Modification Application for Tweed Shire Council Depot (DA22/0793.02)

Review of Hydraulic Assessment

Rev B

February 2025

Appendix B. SWQMP Concept Design

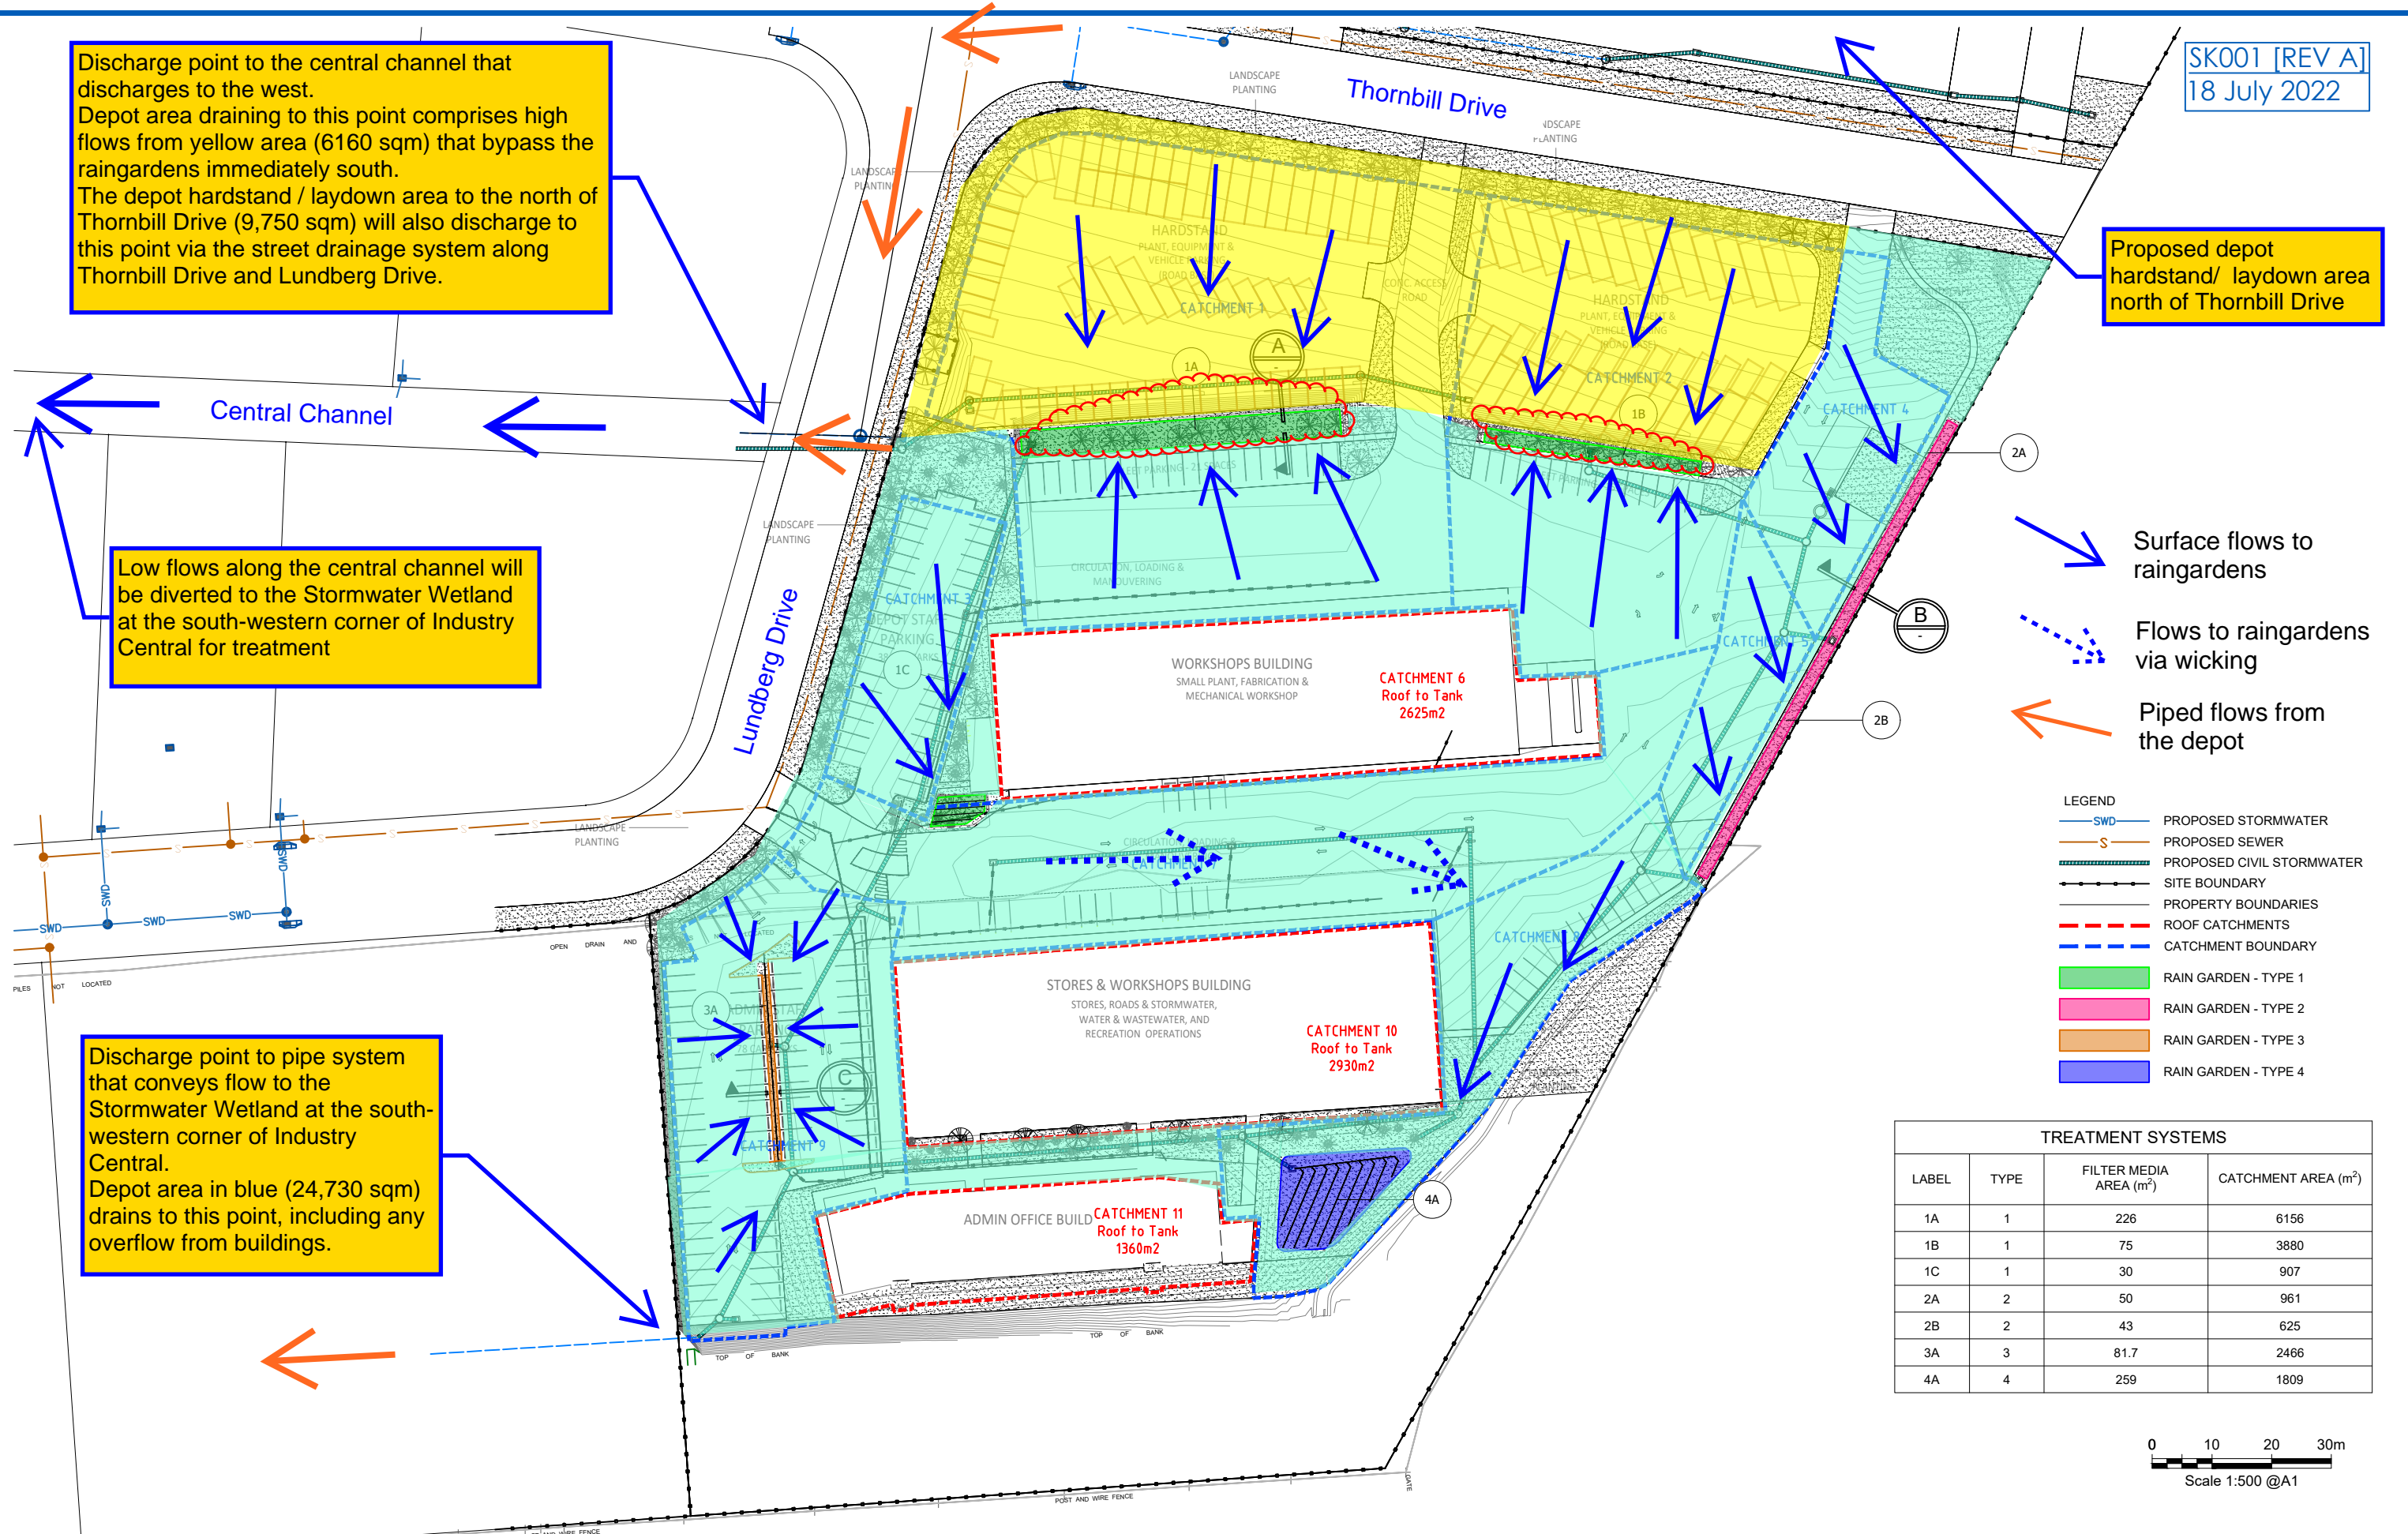
As shown in **Appendix B**, the majority of the depot area will drain to the south-western corner of the site (refer blue areas), from where the stormwater will be piped to the west and into the existing stormwater wetland constructed as part of Industry Central. The northern carparking area at the depot (shown in yellow in **Appendix B**) will drain to two raingardens.

However, during storms larger than the 3-month ARI event any excess flow will discharge to the west into the central channel of the subdivision. Piped stormwater flows from the depot area north of Thornbill Drive will also discharge to the central channel.

Discharge point to the central channel that discharges to the west.
Depot area draining to this point comprises high flows from yellow area (6160 sqm) that bypass the raingardens immediately south.
The depot hardstand / laydown area to the north of Thornbill Drive (9,750 sqm) will also discharge to this point via the street drainage system along Thornbill Drive and Lundberg Drive.
